**National Highway Traffic Safety Administration**

**New Car Assessment Program (NCAP)**

**ACTION:** Final decision notice.

**SUMMARY:** This document announces the agency's decision to implement (with minor modifications) the planned update to the U.S. New Car Assessment Program (NCAP) that the agency announced in its June 26, 2013 request for comments (78 FR 38266). As we discussed in that notice, this update will enhance the program's ability to recommend to consumers vehicle models that have rearview video systems that the agency believes (based on currently available data) will decrease the risk of backover crashes. Further, the program will no longer list electronic stability control (ESC) as a Recommended Advanced Technology Feature because ESC is now required for all light vehicles. For many years, NCAP has provided comparative information on the safety of new vehicles to assist consumers with vehicle purchasing decisions. NCAP was most recently upgraded for model year 2011 to include recommended crash avoidance technologies. Those updates, along with today's updates to NCAP, allow consumers

**Figure 1**

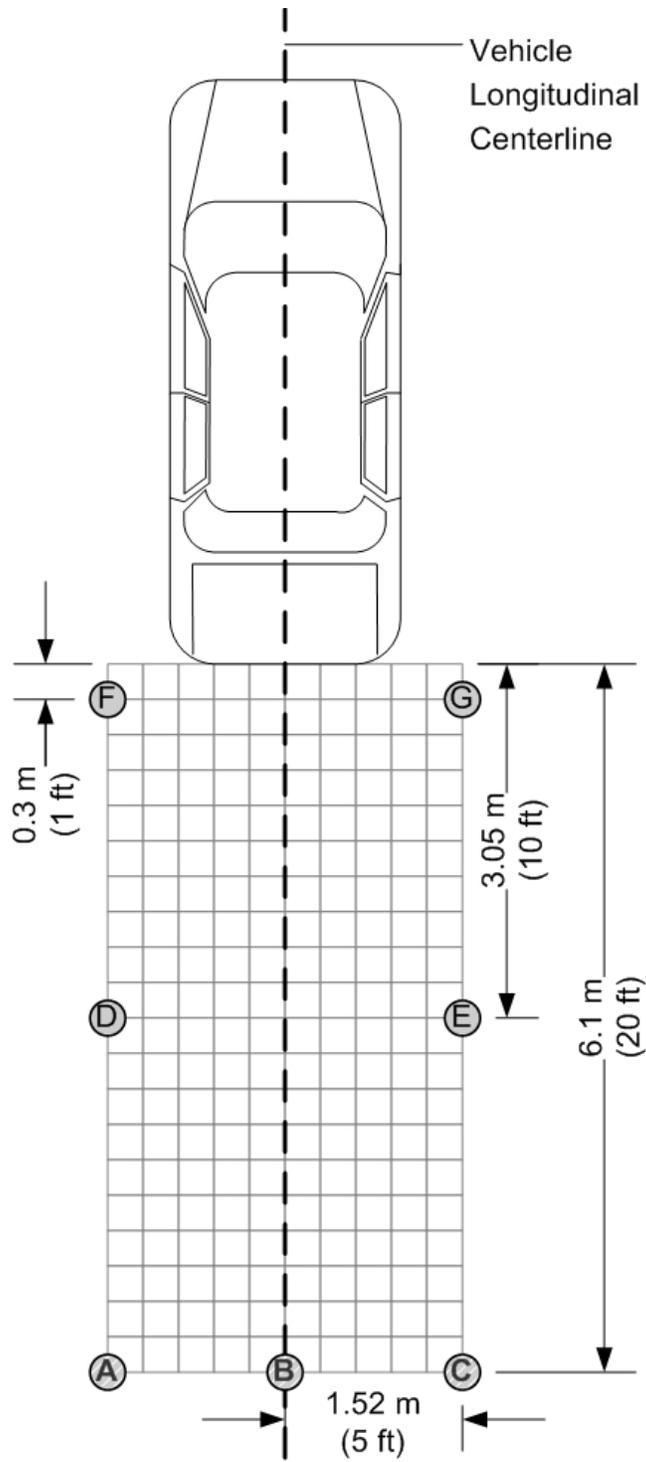
Certain manufacturers expressed two concerns with this test procedure to evaluate the field of view criterion. First, both the Alliance and Global Automakers assert that test objects F and G should be placed in a location that is proportional to the vehicle width (as opposed to 5 feet to the left and right of the vehicle centerline). They contend that vehicles using a 130 degree camera would not cover the required portions of test objects F and G (in their current locations). Second, the Alliance stated that certain vehicles with a low rear height (i.e., a vehicle that is not high off the ground) has less height flexibility for mounting a camera. Thus, the Alliance suggests that vehicles with an upper protected surface of the rearmost body structure of 750 mm or less be required to show only a minimum height of 0.4 meters (half the height) of test objects A through E (objects greater than 10 feet from the vehicle bumper).

In response to the manufacturers' second concern, we note that the portions of the F and G test objects that must be shown are measured by width only in order to accommodate vehicles of varying height and width. Thus, we disagree with the manufacturers that a 130-degree camera is unable to cover the width parameters for test objects F and G. We believe that the diagrams presented by the commenters regarding the inability of the 130-degree camera to cover test objects F and G fail to consider the three-dimensional properties of a camera's viewing angles. As Magna, a rearview video system manufacturer, stated in their comments to the NPRM to amend FMVSS No. 111, a 130-degree camera can readily cover the 5.9-inch (150-mm) width parameters of test objects F and G when mounting height and camera pitch is considered.<sup>14</sup>

We disagree with the manufacturers that this procedure for evaluating the field of view criterion does not accommodate vehicles with rearview video systems using a 130 degree camera or vehicles with a low rear height. When we originally developed this test procedure for the NPRM to amend FMVSS No. 111, we specifically designed this test procedure to be able to accommodate these types of vehicle designs. In response to the manufacturers' first concern, it seems clear that if we take into account three-dimensional nature of a camera's field of view, a 130 degree camera will cover the specified areas of all the test objects even if the vehicle has a low rear height. In tests conducted by the agency, the vast majority of vehicles equipped with rearview video systems were capable of meeting the field of view requirements as proposed in the NPRM.<sup>13</sup> Thus, we are unaware of any camera that has a vertical angle limitation which would prevent it from easily being mounted at a pitch which covers the full height of test objects A through E.

Since the available information indicates that existing systems either already conform to (or can be easily adjusted to conform to) the field of view criterion from the June 26, 2013 request for comments, we believe there is no reason to adjust this criterion to reduce the field of view below the 10-foot by 20-foot zone where there is the highest risk of a backover crash.
